ADDENDUM NO. 2

Date: November 16, 2021

**Hobbs Middle School HVAC Replacement
Shelley School District No. 60
Shelley, Idaho**

A1.1

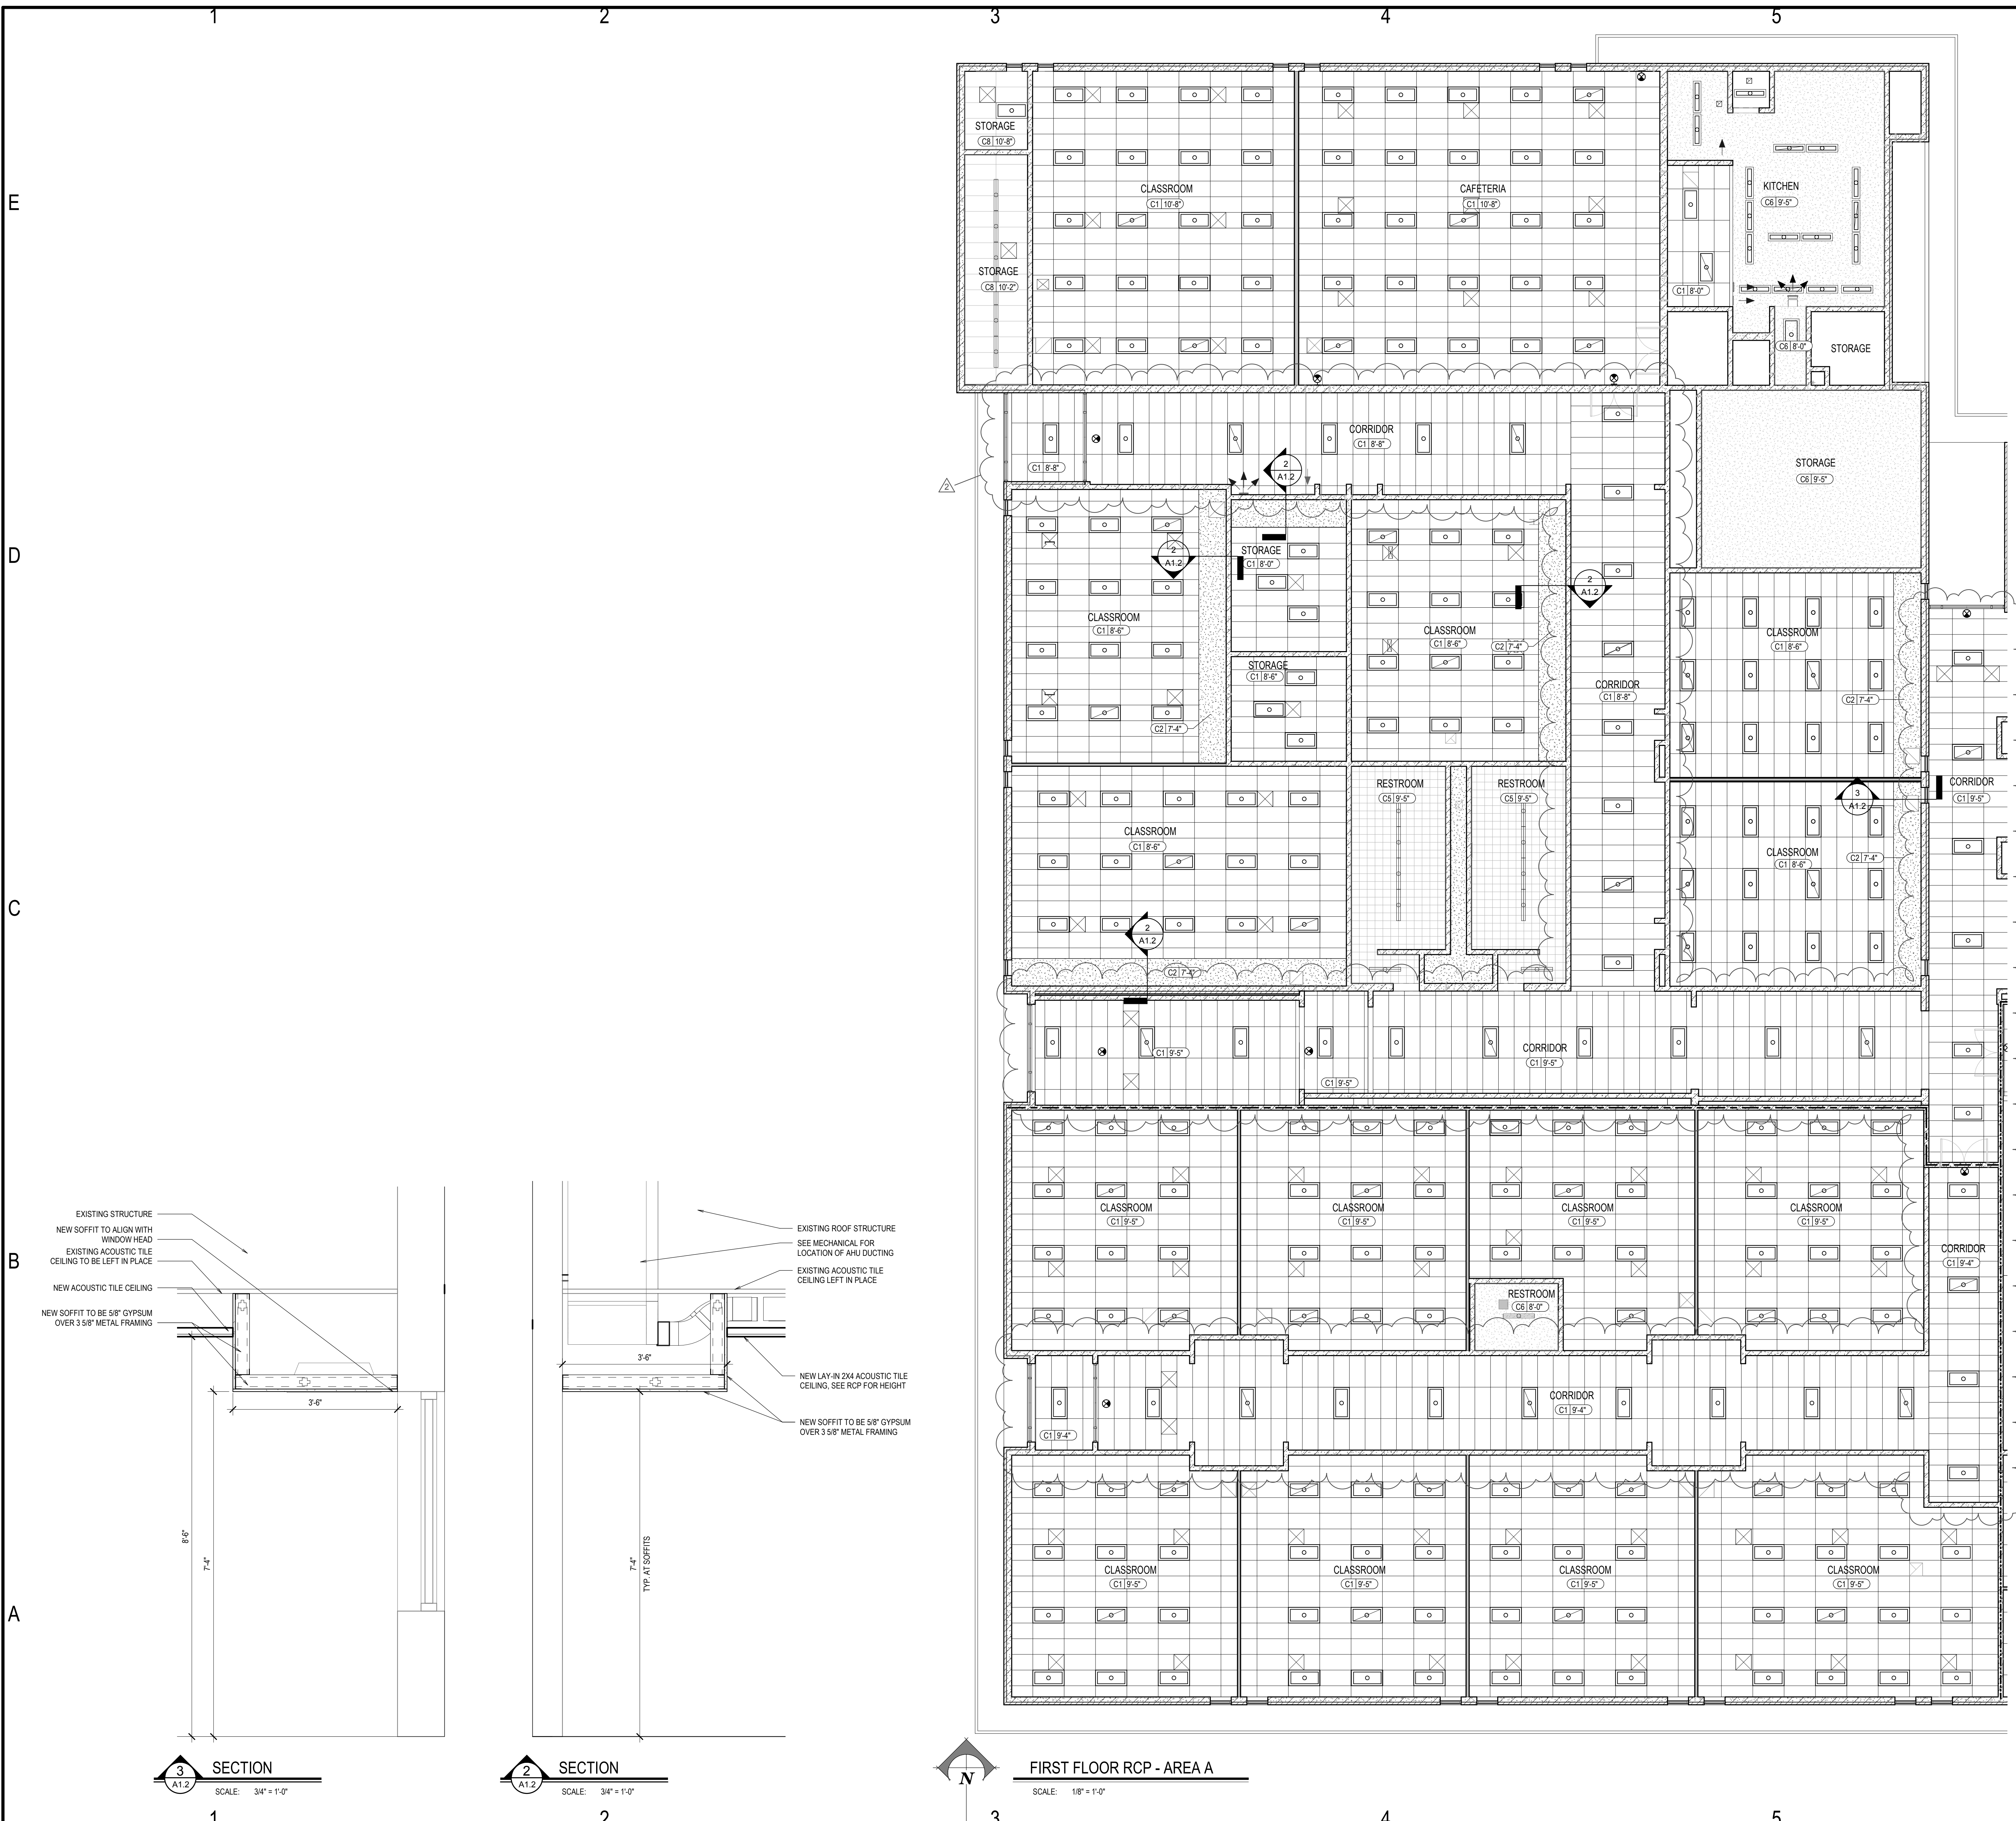
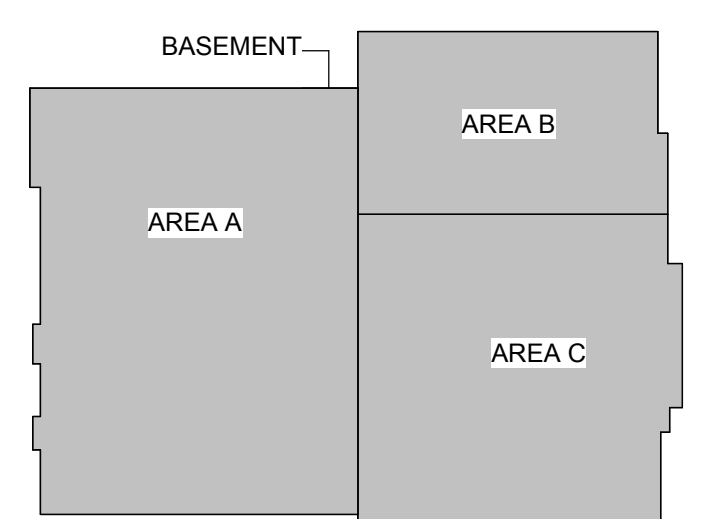
1. Add Alternate #1 to be deleted. Scope of work from add alternate #1 now to be included in the base bid. That work consists of demolishing and removing the existing corridor ceilings and installing new ceilings per the revised addendum drawings. Also included are rotating the corridor lights, so all corridor lighting is perpendicular to the flow of traffic. See revised sheets A1.0-A1.4. for corridor lighting orientation and location. Sheet A2.2 to be removed from the bid set.
2. No bids will be accepted by fax or email.
3. Existing floors to remain.
4. School district will remove and reinstall all furniture as needed.

1. See revised Sheet A1.0-A1.4
 - a. Refer to clouded changes in the attached sheets.
